HISTORIC AND DESIGN REVIEW COMMISSION

April 20, 2022

HDRC CASE NO: 2022-117
ADDRESS: 527 HAYS ST
LEGAL DESCRIPTION: NCB 529 BLK 2 LOT E 51.12 FT OF S 92.5 FT OF 14
ZONING: R-6, H
CITY COUNCIL DIST.: 2
DISTRICT: Dignowity Hill Historic District
APPLICANT: Megan Suermann/SUERMAN PATRICK & SUERMANN
MEGAN
OWNER: Megan Suermann/SUERMAN PATRICK & SUERMANN
MEGAN
TYPE OF WORK: Window replacement, shutter installation, exterior alterations,
painting
APPLICATION RECEIVED: March 04, 2022
60-DAY REVIEW: Not applicable due to City Council Emergency Orders
CASE MANAGER: Claudia Espinosa
REQUEST:

The applicant is requesting a Certificate of Appropriateness for approval to:

Example of window to be replaced (same size in white vinyl), will convert extra room back into a garage

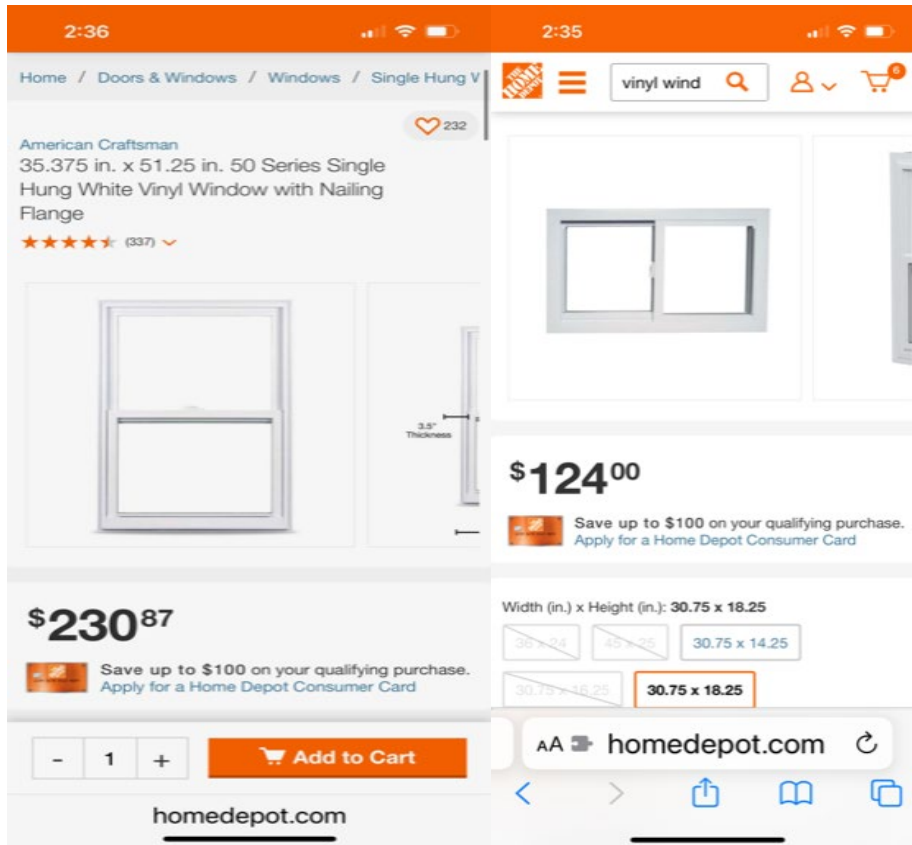
- c. **WINDOW REPLACEMENT** – The applicant has proposed to replace the existing, aluminum windows with new vinyl windows. The windows that have been proposed by the applicant are white, vinyl windows that feature a nailing fin. Staff finds the proposed replacement windows to be inconsistent with the Guidelines and staff's standards for replacement windows. The replacement of the existing, aluminum windows may be appropriate provided the replacement product meets staff's standards, noted in the applicable citations.

Damage to brick from settling foundation on right and left side of house

Breathable material I'd like to use over brick after foundation repair to hide cracks to improve aesthetics.

- 1. Staff does not recommend approval of item #1, the painting/limewashing of brick, based on finding b. Staff recommends the brick remain unpainted.
- 2. Staff does not recommend approval of item #2, the replacement of the existing, aluminum windows with white vinyl windows, as noted in finding c. Staff recommends that the applicant install windows that are consistent with staff's standards for replacement windows, as noted in the applicable citations.
- 3. Staff does not recommend approval of item #3, the installation of window shutters based on finding d.

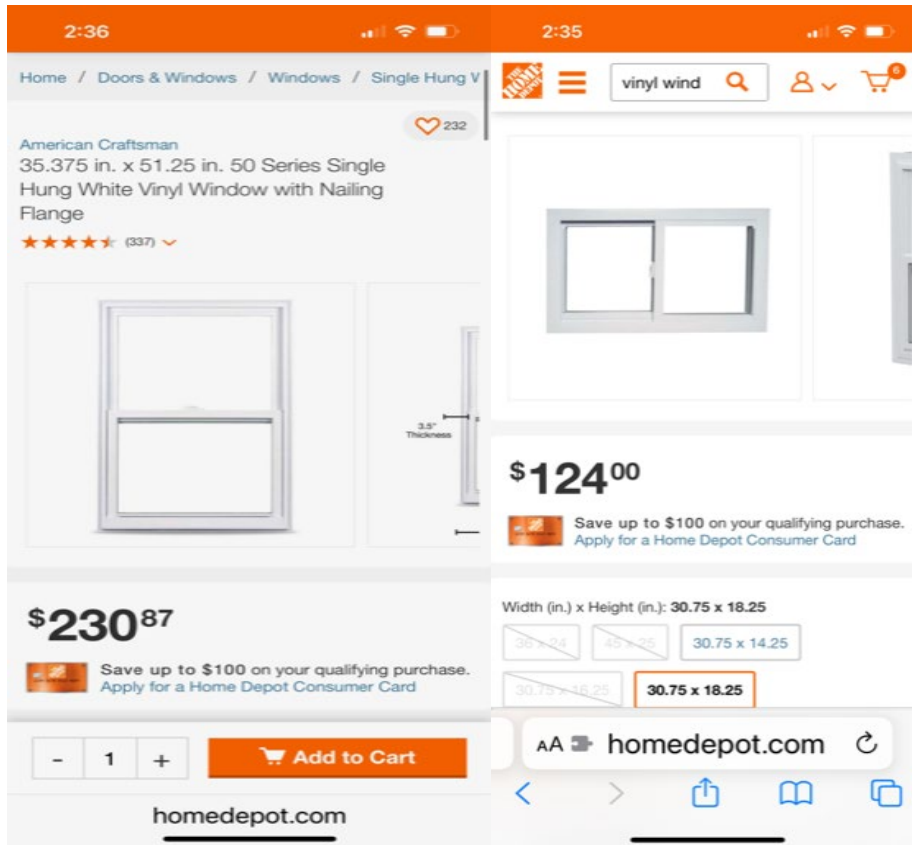
- d. **SHUTTER INSTALLATION** – The applicant has proposed to install black shutters at the front windows. The Guidelines for Exterior Maintenance and Alterations 6.B.x. notes that shutters should not be installed where they did not historically exist. Staff finds the proposed installation of shutters to be inconsistent with the Guidelines.

I'd like to replace aluminum windows with white vinyl windows to improve energy efficiency and to improve operability after foundation repair. They will be the same size, no framing required.

I'd like to add shutters to the front windows to improve aesthetics. Shutters were very popular mid-century modern exterior. They will be the same height and width as the front windows and appear operational.

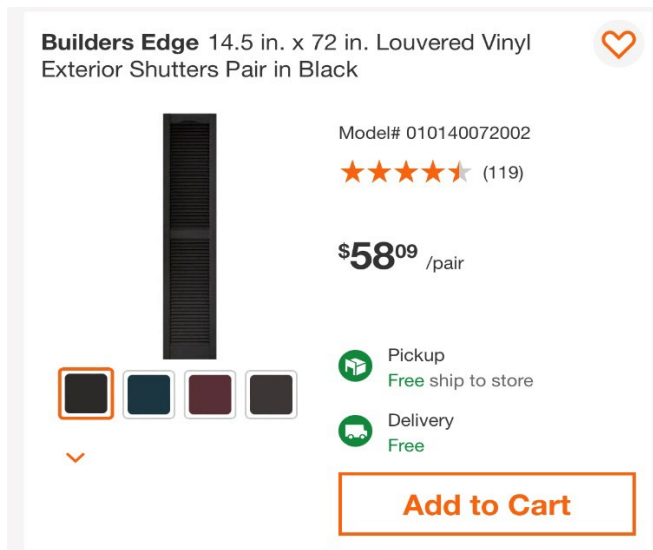
I'd like to replace aluminum windows with white vinyl windows to improve energy efficiency and to improve operability after foundation repair. They will be the same size, no framing required.

I'd like to add shutters to the front windows to improve aesthetics. Shutters were very popular mid-century modern exterior. They will be the same height and width as the front windows and appear operational.
